Permit Fact Sheet

Permit Number	WI-0056294-08-0
Permittee Name	Back Road Beef LLC
Permitted Facility Address	W6920 Grogan Road Fort Atkinson
Permit Term	November 01, 2026 to October 31, 2031
Discharge Location	W6919 Grogan Road Fort Atkinson, WI 53538; SEQ and NEQ SEC 31; T5N; R14E; Jefferson County, WI
Receiving Water	unnamed tributaries within the Lake Koshkonong and Rock River Watershed, and groundwaters of the state
Discharge Type	Existing

Subject: Inspection Report Summary Letter

CAFO Compliance Report: May 2, 2024

Map 1. Site map from previous inspection report dated December 12, 2018. Compost area is south of Lot 11.

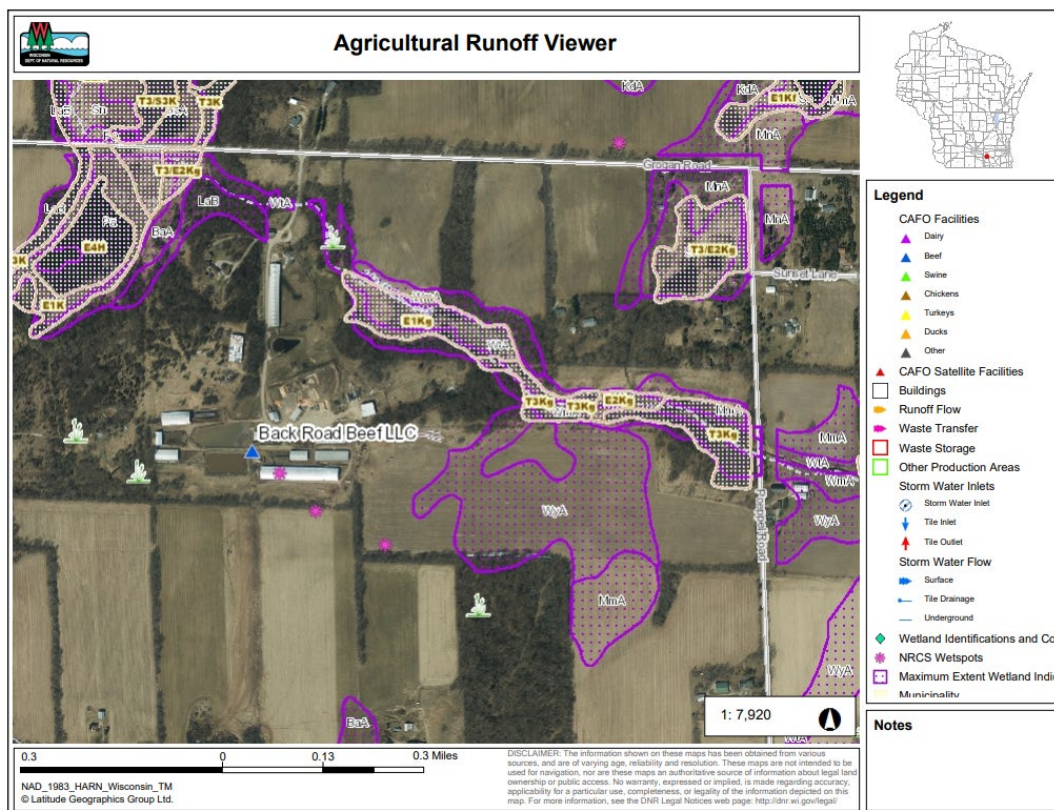
- Update Site Map should include:
 - o Compost Area
 - o Underground Pipeline
 - o Stormwater flow paths
 - o As well as existing structures and transfers

- Submit a complete permit application by June 30, 2024
- Any further actions identified during the review of submitted evaluation dated May 29, 2020.
- Update site map with underground pipelines, storm water, and compost area.
